QUALITY ASSURANCE -- NON-CONFORMANCE REPORT

Component: Bike path Cantilever Bracket BK001-046

Reference Description: Heat Straightening re-performed without approval on Bike path Cantilever Bracket BK001-046

Subject: NCR No. ZPMC-0578

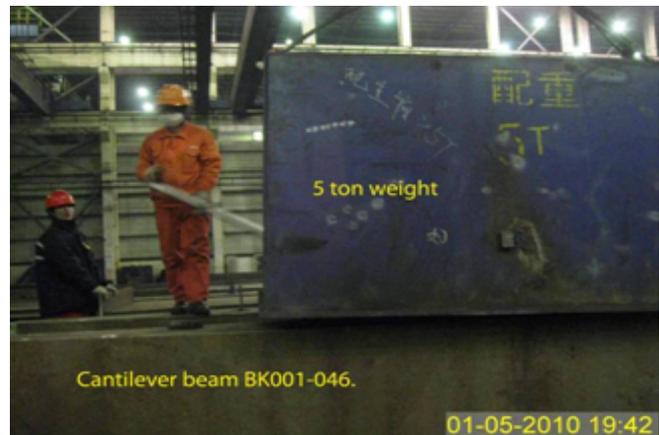
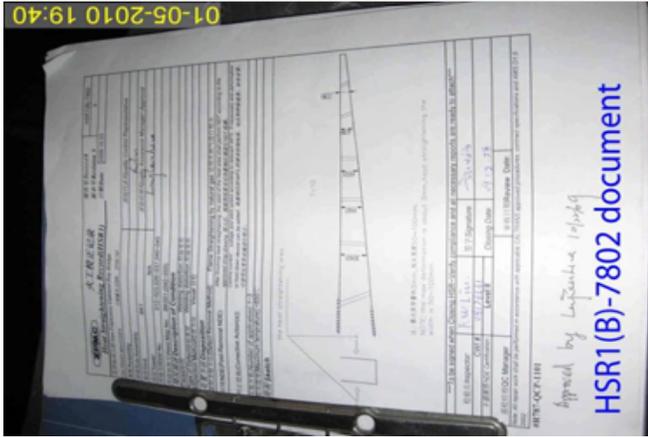
During Quality Assurance in-process observations of the fabrication of bike path cantilever brackets in OBG bay 5, this Quality Assurance Inspector (QA) discovered the following issues:

- ZPMC personnel heat straightening bike path cantilever bracket identified as BK001-046.
- ZPMC had placed a 5 ton weight on BK001-046 10 mm thick side plate during the heat straightening process.
- Heat straightening document HSR1 (B)-7802 revision 0 was referenced as being the controlling document by ZPMC QC CWI Mr. Li Jia.
- The referenced document does not indicate any weight and/or mechanical force being used during this process.
- Document HSR1(B)-7802 showed that the work has been completed and was signed off by Mr. Liu on 12-28-2009.

AWS D1.5/2002 Section 3.7.3; “Members distorted by welding shall be straightened by mechanical means or by carefully supervised application of a limited amount of localized heat as approved by the engineer...The part to be heated for straightening shall be substantially free of stress and from external forces...”

ZPMC QC provided the incorrect HSR at this time. Attached is the correct HSR which shows the use of the outside force. Per discussion in China, ZPMC has issued an internal NCR to the QC to reiterate the importance of verifying that the correct documents are on hand prior to beginning work to prevent future occurrences of this. Based on this ZPMC requests closure of this NCR.

The provided documentation is sufficient to close this NCR.

简图 Sketch

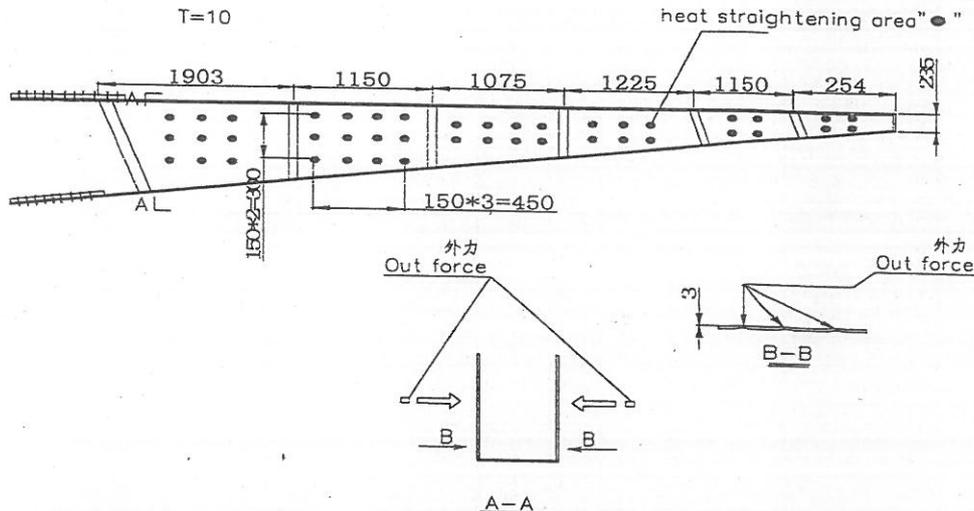
Wrong heat straightening report was provided to inspector. ZPMC is providing the correct one what shows the mechanical force to be used on this case. Based on this, ZPMC is requesting closure of this NCR.

注: 最大变形量约3mm, 校火宽度50~100mm.

NOTE: the max deformation is about 3mm, heat straightening the width is 50~100mm.
